ADDENDUM NO. 1

RE: HIGH SCHOOL #13

Howard County Public School System

Bid Number: 016.20.B4

dwg
 ADD_1_E7

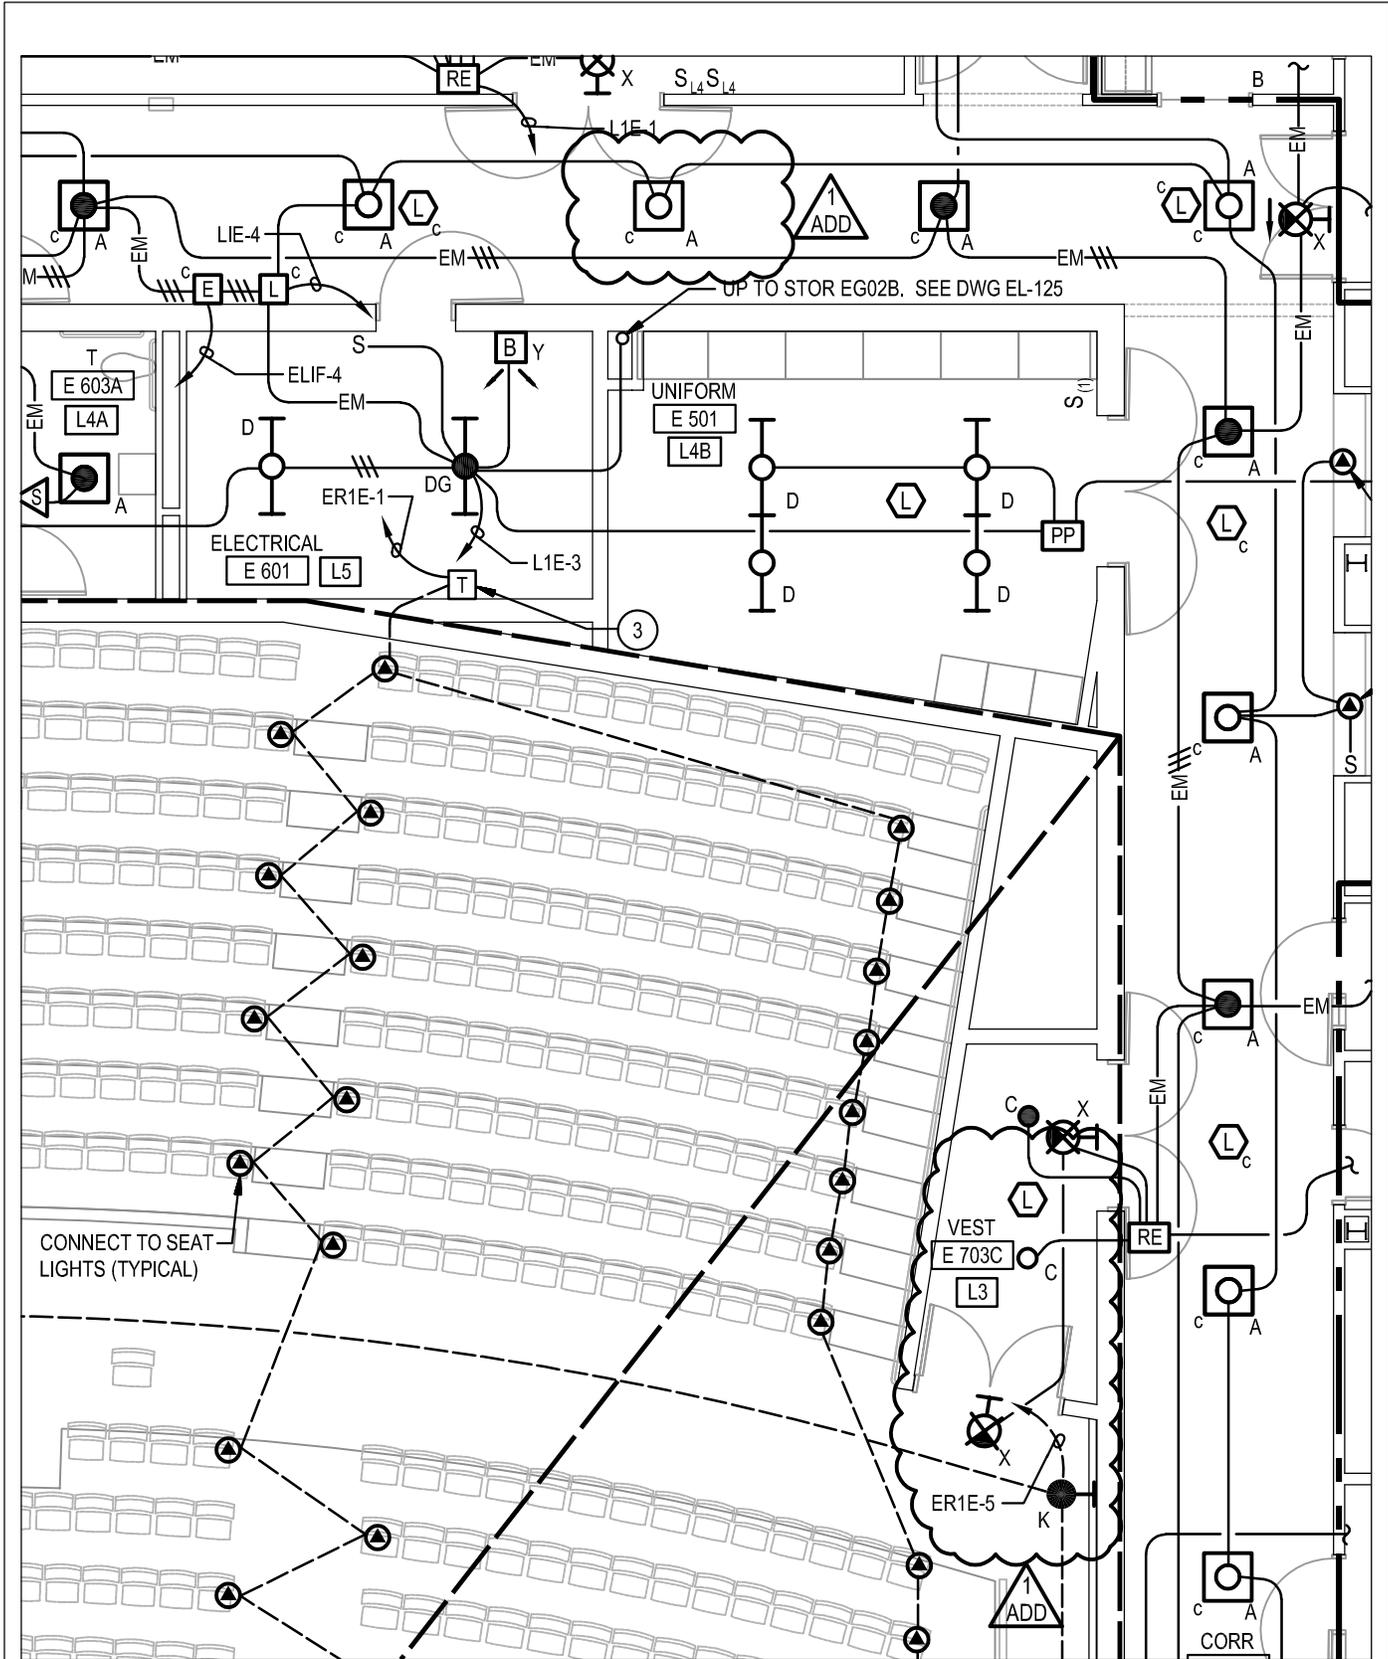
REVISE Fixture designation to downlight at Elev B Lobby to type C. Refer to sketch ADD_I_E7.

dwg
 ADD_1_E8

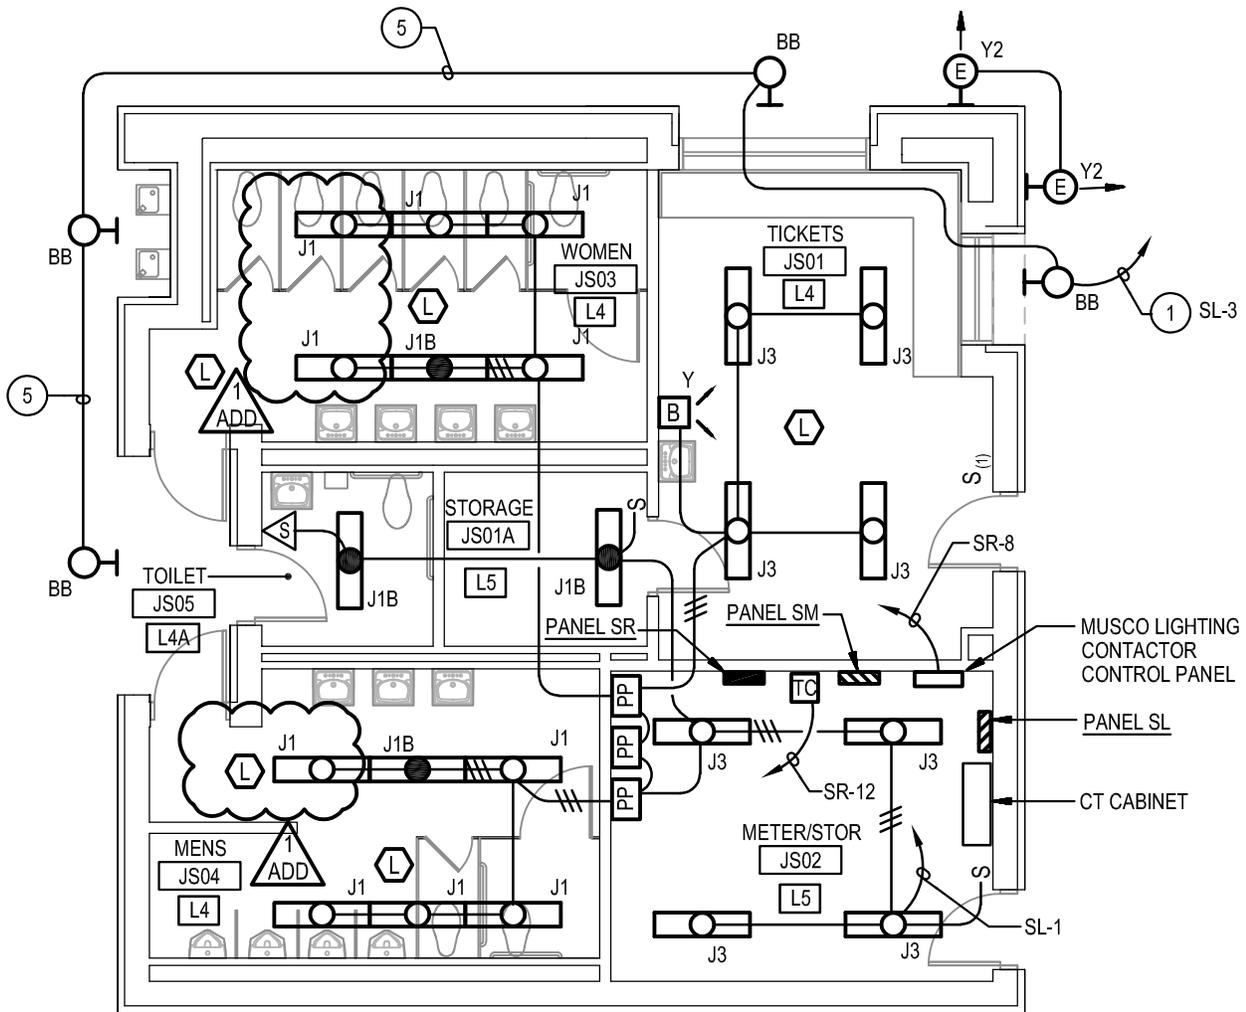
ADD Fixture designation type A to light fixture in Corridor E 060. Refer to sketch ADD_I_E8.

ADD Fixture designation type K to light fixture in Auditorium. Refer to sketch ADD_I_E8.

3. Light fixture located in the corridor E060, north of room E501 on drawing EL-115 is not labeled.
4. Lighting fixture located in the Auditorium located northeast of the stage on drawing EL-115 is not labeled.
